**ROCKFORD BOARD OF EDUCATION  
INVITATION FOR BID ON SUPPLIES, MATERIALS, EQUIPMENT OR SERVICES  
FOR SCHOOL DISTRICT NO. 205  
ROCKFORD, ILLINOIS**

IFB No.        **17-40 Rockford Public School District 205 School B, Zone 1**

RE:        **ADDENDUM NO. 5**

Rockford Public School District 205  
School B, Zone 1  
Rockford, IL  
Cannon Project No. 005005.00

C17

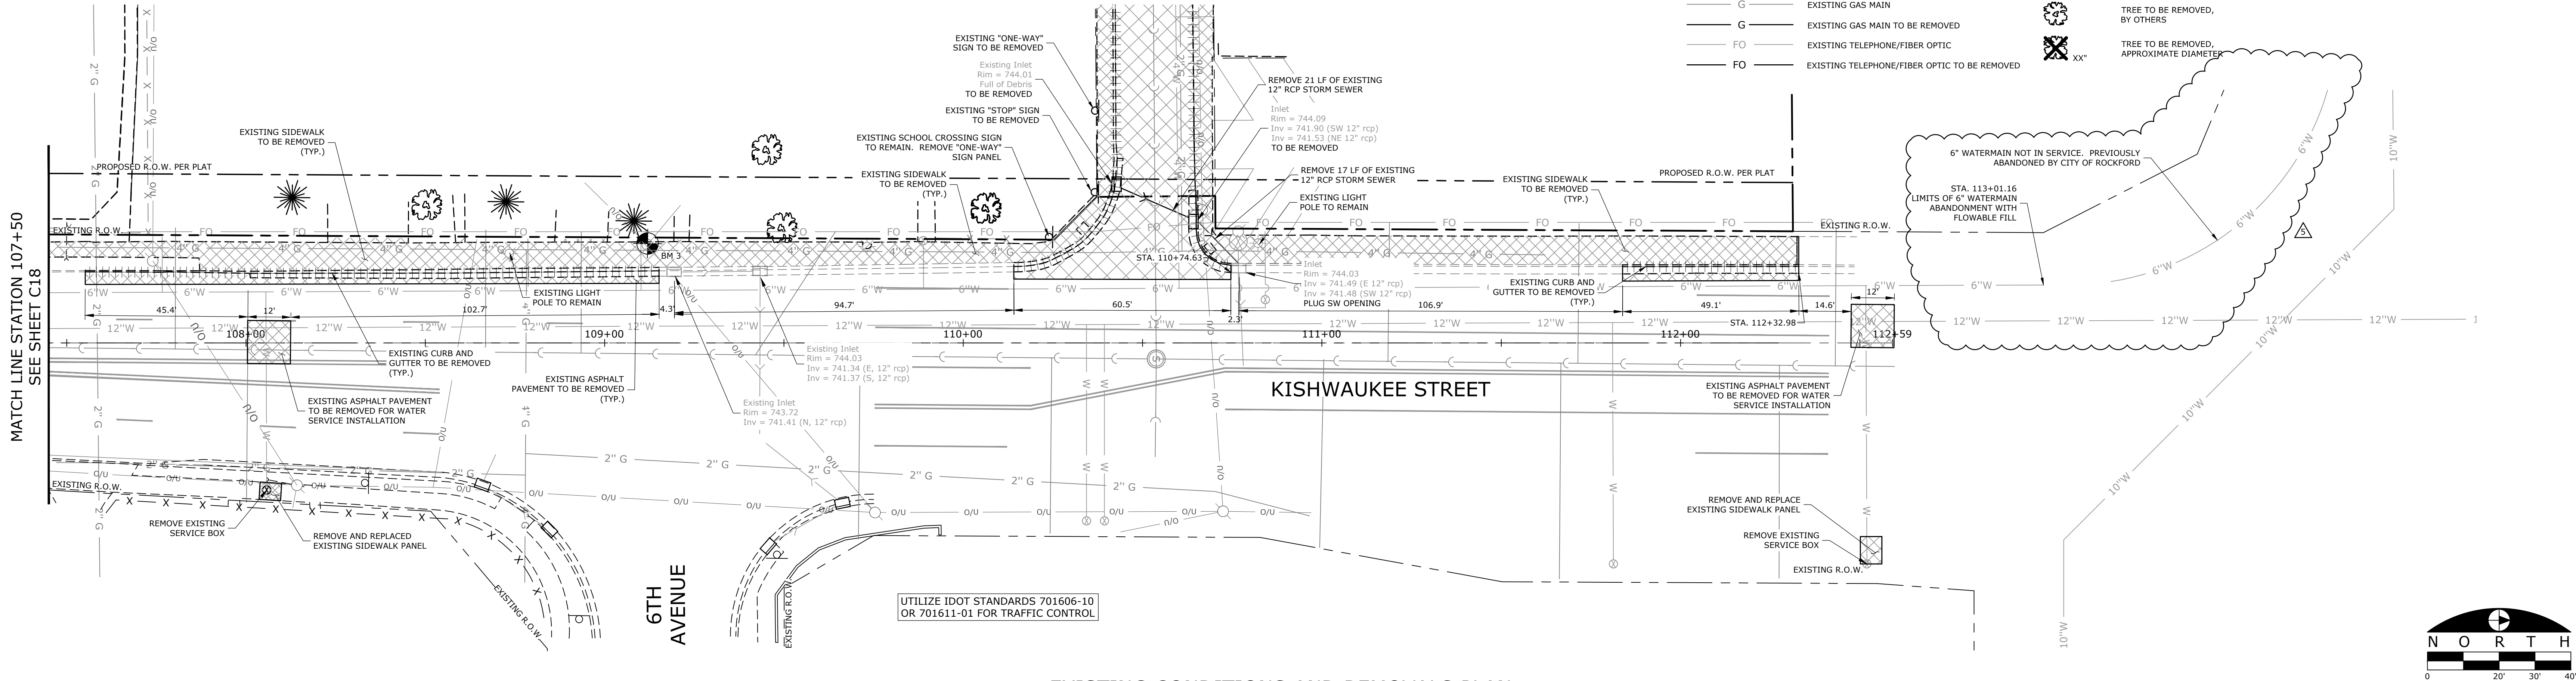
- A. Added watermain encasement where crossing gasketed storm sewer per City of Rockford review comments.
6. C19 – KISHWAUKEE STREET CORRIDOR PLAN STA. 107+50 – 112+50

## PAVEMENT DETAILS

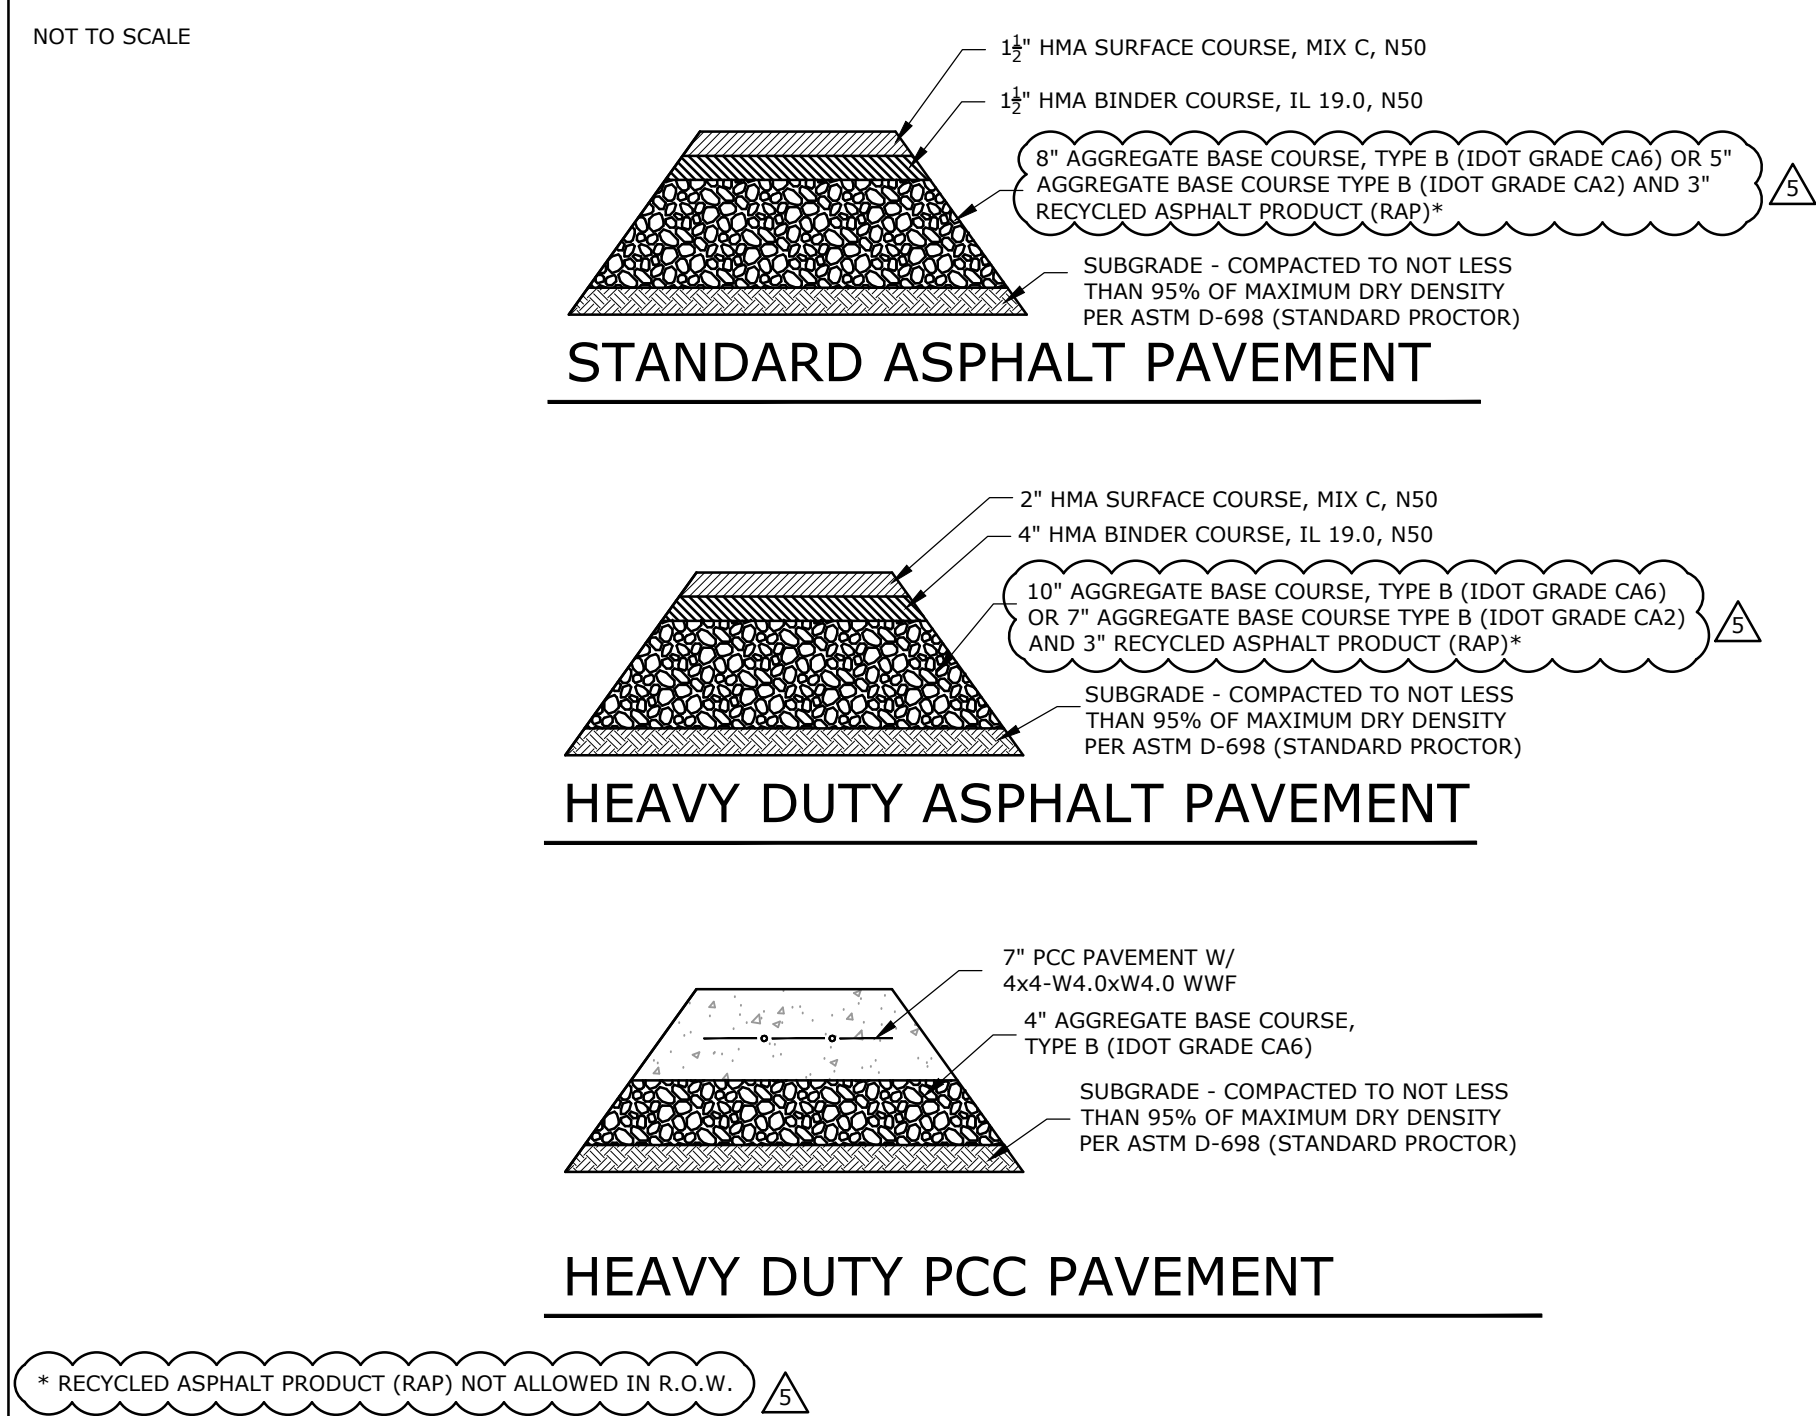
- B. Revised STANDARD DUTY ASPHALT PAVEMENT detail to permit 5" of CA2 and 3" RAP, in lieu of 8" of CA6
  - C. Revised HEAVY DUTY ASPHALT PAVEMENT detail to permit 7" of CA2 and 3" RAP, in lieu of 10" of CA6.

- D. Added note to PAVEMENT DETAILS regarding the use of RAP in right-of-way.
9. C28 – IDOT DETAIL:
  - A. Added Pavement Joint Details.
10. C31 – WATER DETAILS 2:
